PARTS & SERVICE NEWS

REF NO.	AA03027
DATE	February 3, 2003

SUBJECT: ENGINE FAN GUARD QUALITY.

PURPOSE: Replacement of the engine fan guards.

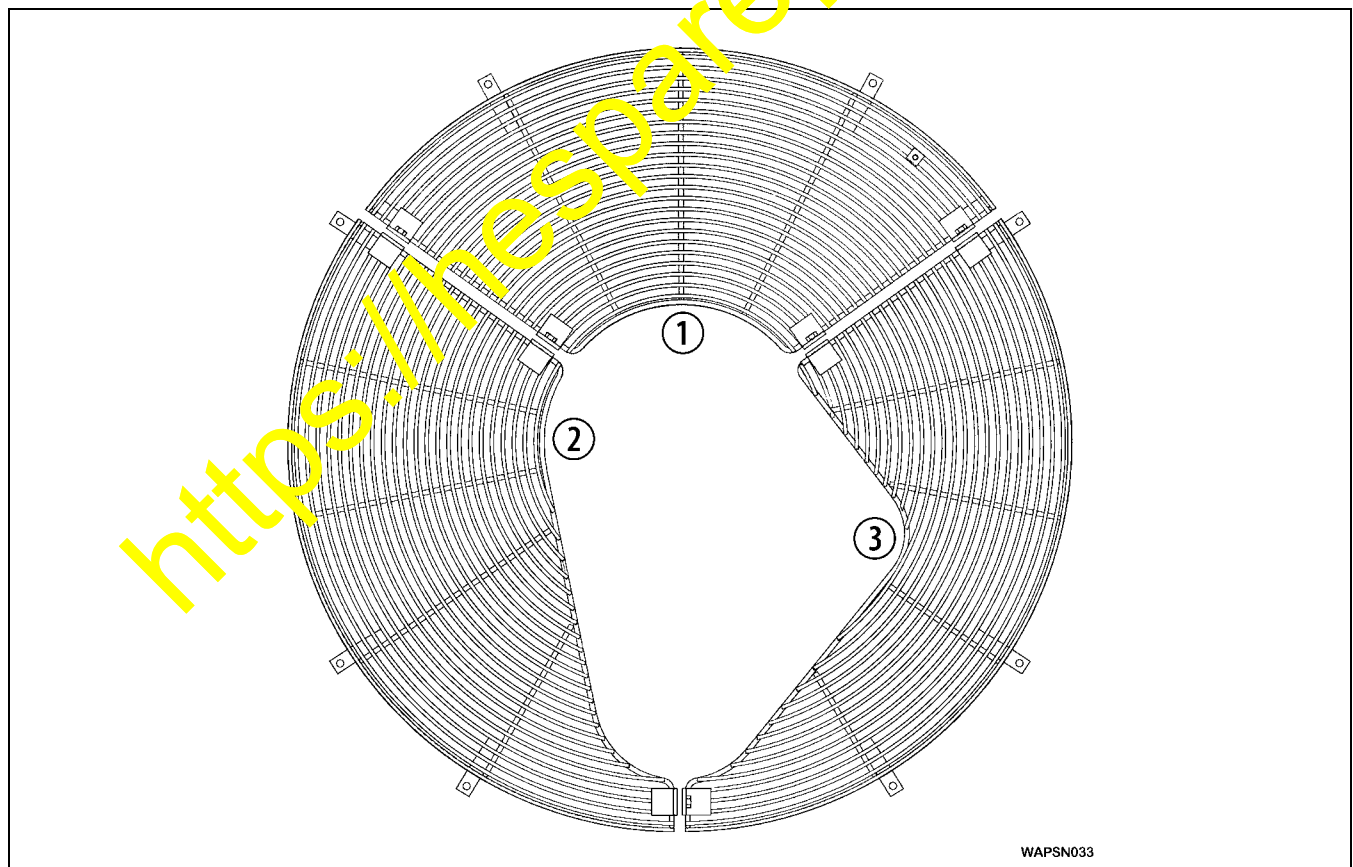
DESCRIPTION: The original parts were not made to the required design. They may not have the appropriate welding at the wire to wire connection points. Resistance welding was used instead of the required fillet welds (2).

1. Replace the current engine fan guards with the updated guards. Follow the shop manual procedure.
